Side Flange Modification Reference for TOYOTA Supra JZA80 2JZ-GTE Before Minor Change 6MT

Picture 1

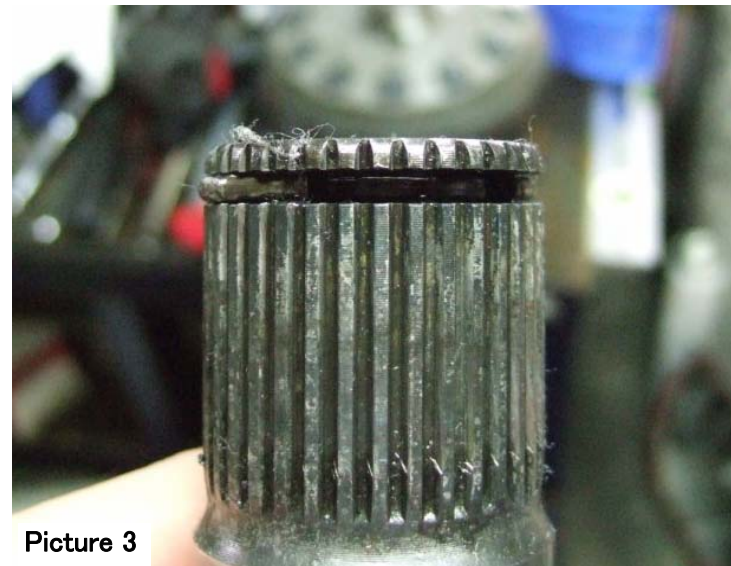
On the top of TOYOTA OEM side flanges for JZA80 2JZ-GTE Before Minor Change 6MT have a protruding area (trapezoid seen from the side) shown as Picture 1.

The protruding area interferes with the OS GIKEN Super Lock LSD inside parts.

Please shave the protruding area flat shown as Picture 2 and 3.
